DATE: 2023-08-10

MODEL: SR3 / SR10

**TRANSPORT PUSHRODS**

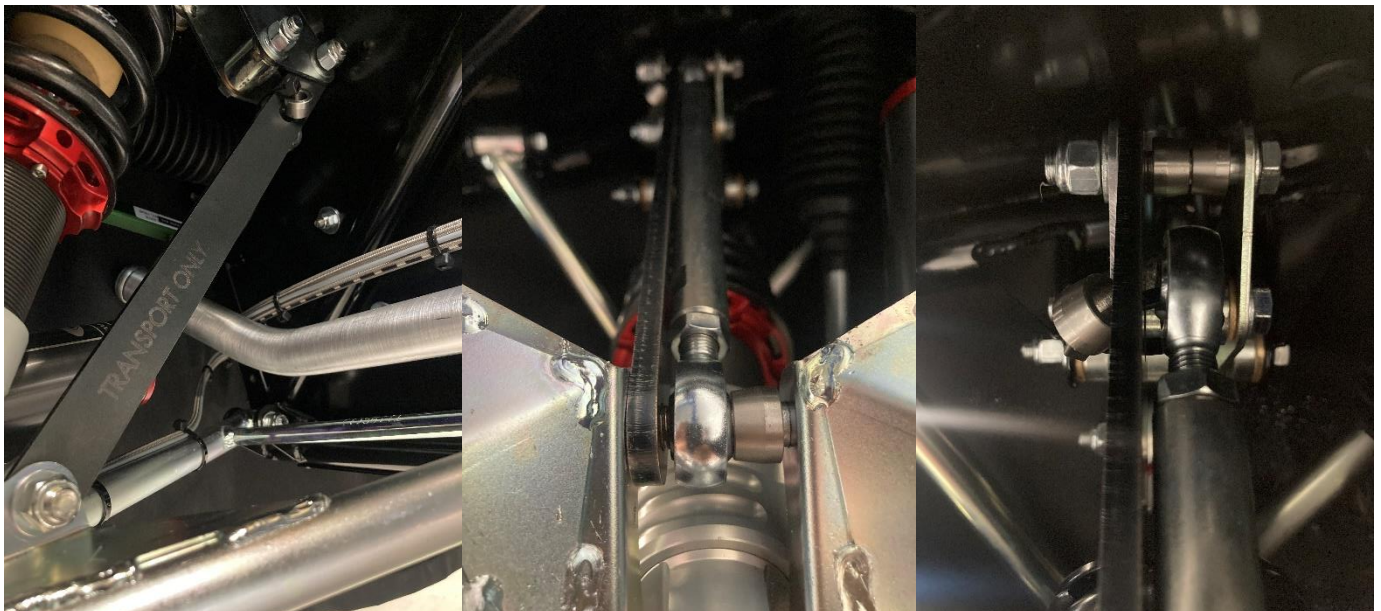
Effective from 1<sup>st</sup> August 2023 all Radical SR3 and SR10 production builds will be fitted with Transport Pushrods (AT0179 – single) alongside standard front push rods to increase splitter ground clearance to 80mm allowing for easier loading and unloading.

As per images below, the Transport Pushrods will be mounted to the side of a standard pushrod. The removed spacers will be cable tied up together with the rocker side rose joint through the eyelet onto the plate.

Bolts will be fitted loosely to prevent binding during transport.

Dealers should remove the transport pushrods ahead of normal PDI flat patch.

**Cars must NOT be driven with Transport Pushrods fitted!**
